**Embraer Empresa Brasileira de Aeronáutica
S.A. (Embraer)**

for an exemption from § 25.979(b)(2) of Title 14,
Code of Federal Regulations

Regulatory Docket No.
FAA-2002-13283

GRANT OF EXEMPTION

FIGURE 1 – EMB-135BJ SHADOW AREAS

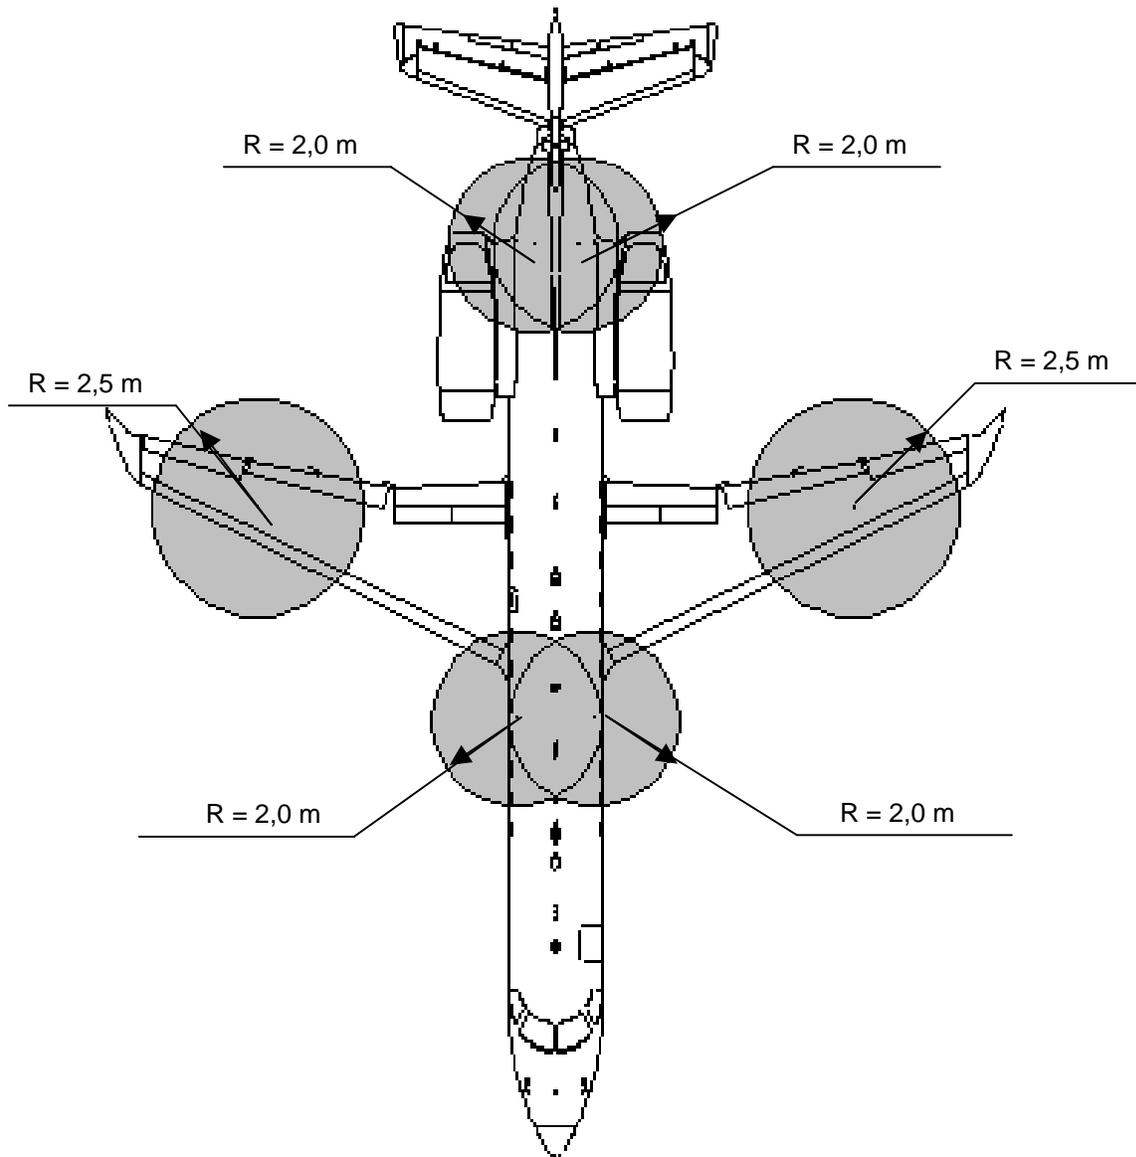
The parking of any kind of vehicle or equipment inside the areas of fuel discharge will be prohibited during the airplane refueling operation. There will be a placard in the refueling station instructing this procedure to the operators. This will serve to minimize the presence of an ignition source external to the airplane near the vent outlets.

The attached sketches show the EMB-135BJ and EMB-145XR areas of fuel discharge in the event of fuel tanks overfilling and the placard that will be displayed in the refueling station.
